THE UNIVERSITY OF TEXAS AT AUSTIN

Nuclear Engineering Teaching Laboratory • <http://www.me.utexas.edu/~netl>

Ref: Letter of March 28 2008 (ML080920755) Docket 50-602

Subject: Request to withdraw previous Technical Specification change request and submission of new change request.

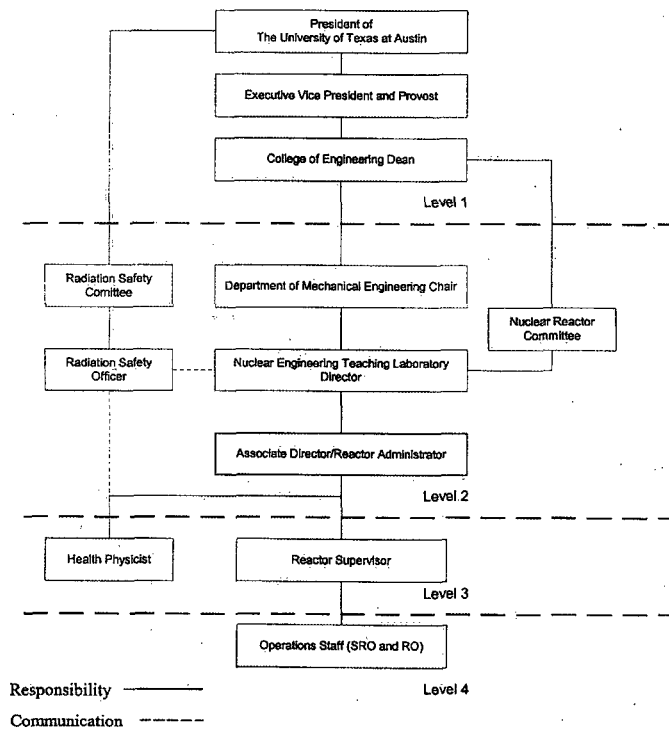
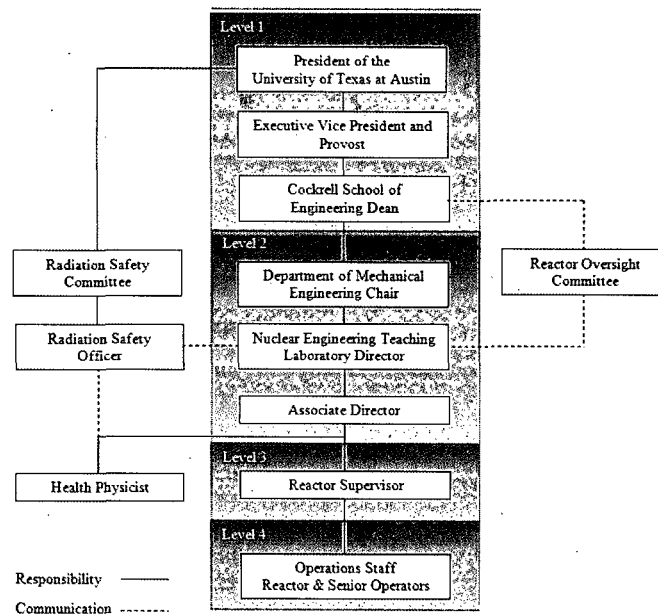
In 2001 a change to the Technical Specifications provided an organizational chart that included line management for reactor operations integrated with radiation safety and oversight functions. The arrangement of labels for Level 1 and Level 2 personnel did not clearly delineate between line management and oversight responsibilities, and the committee tasked with oversight of facility safety is labeled Nuclear Reactor Committee (the name Reactor Oversight Committee is being used internally to avoid confusion in using committee initials). These changes are strictly administrative in nature.

6.1.1 diagram and the use of the word "permanent" is inconsistent thus we request the diagram change to indicate line management and the reference to line management in this section.
